State of New Mexico
Energy, Minerals and Natural Resources Department

30-039-05088 AXI APACHE A #003

Re: Permanent Abandonment
Well: DJR AXI Apache A3

PLUG AND ABANDONMENT PROCEDURE

Proposed

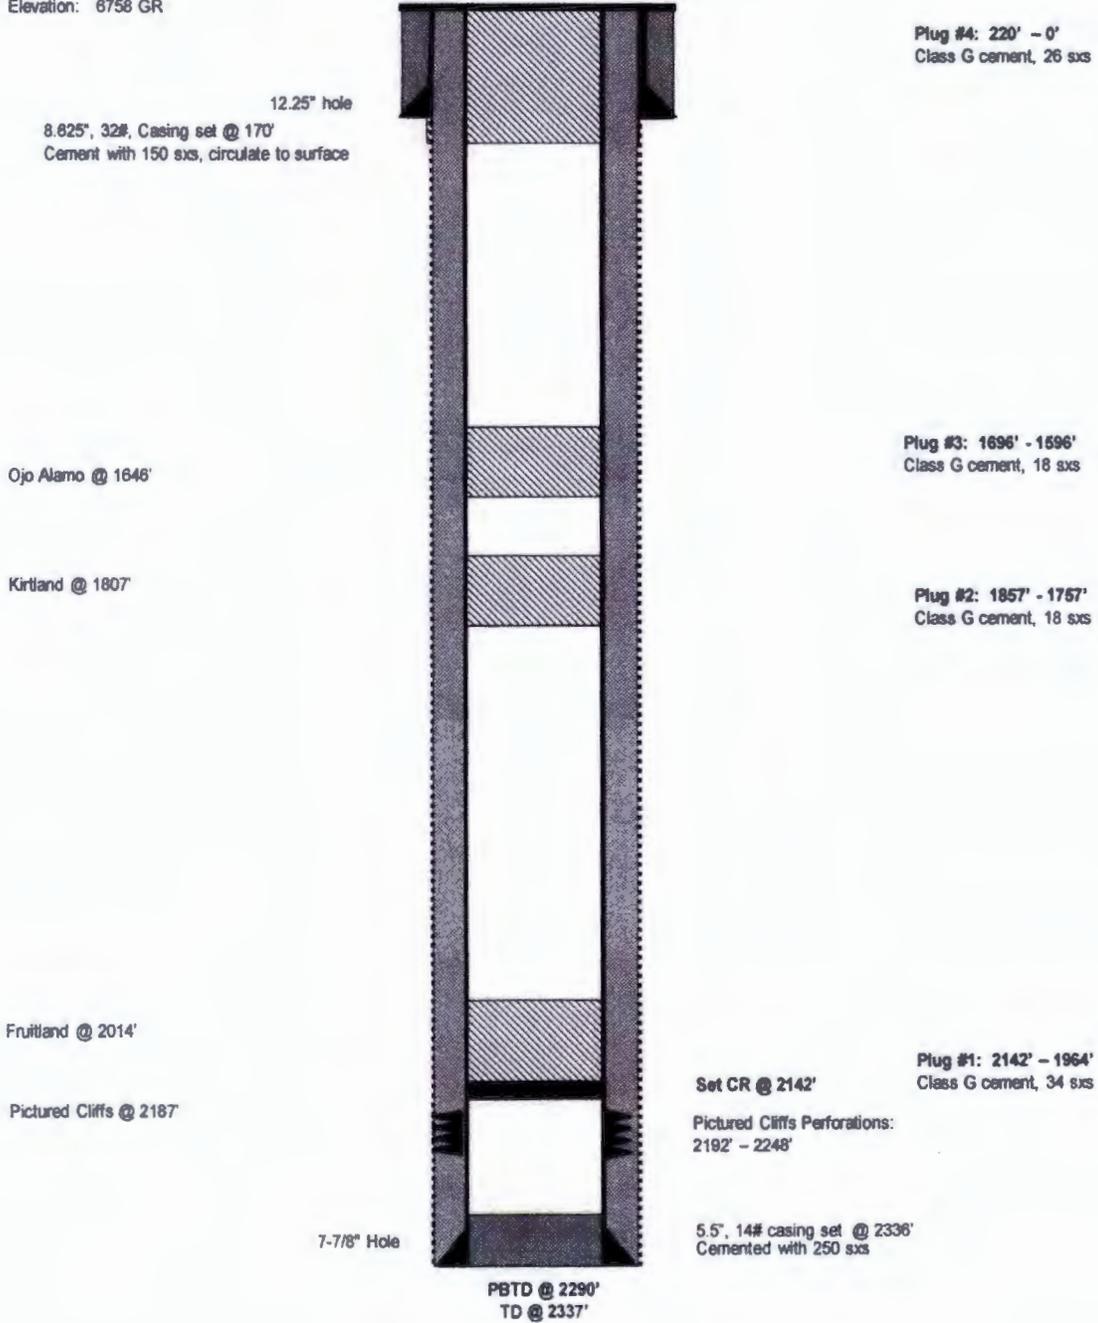
- Notify NMOCD 24hrs prior to beginning operations.
- Combine Plugs #1, #2 & #3 to 2142'-1540'
BLM picks: OCD picks:
Fruitland @ 1930' Fruitland @ 2052'.
Kirtland @ 1710' Kirtland @ 1830'
Ojo Alamo @ 1590' Ojo Alamo @ 1650'
- Add additional plug to cover the Nacimiento top 340'-585'; BLM Nacimiento pick @ 535'; OCD Nacimiento pick @ 390'.

1. Plugging operations authorized are subject to the attached "General Requirements for Permanent Abandonment of Wells on Federal and Indian Lease."
2. Farmington Office is to be notified at least 24 hours before the plugging operations commence (505) 564-7750.
3. The following modifications to the plugging program:
 - a. Plug 1: BLM picks top of Fruitland at 1930'. Required top of plug 1820'
 - b. Plug 2: BLM picks top of Kirtland at 1710'. Required top of plug 1640'
 - c. Plug 3: BLM picks top of Ojo Alamo at 1590'. Required top of plug 1540'
 - d. Added Plug: BLM picks top to Naciminto at 535'. Required top of plug 485'
